Released under the Creative Commons Attribution Share-Alike 3.0 License http://creativecommons.org/licenses/by-sa/3.0			☐	☐
TITLE: \${PROJECTNAME}		SFE	SFE	
Design by: N. Seidle			REV: v1.2	
Date: \${CURRENT_DATE}			Sheet: \${#}/\${##}	
Size: User			Rev:	
KiCad E.D.A. eeschema 7.0.6			Id: 1/1

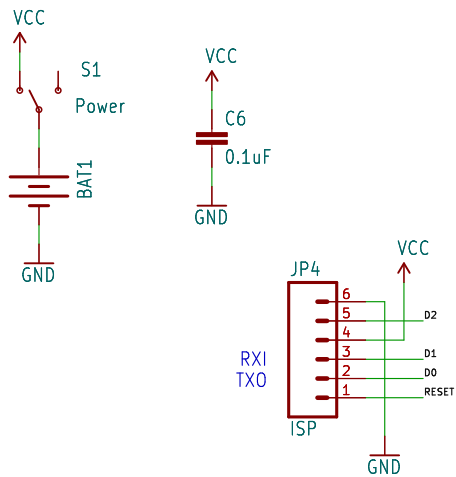
Changes to v1.2:
Corrected FP for CR2032 holder
Removed 10k pull up on RES
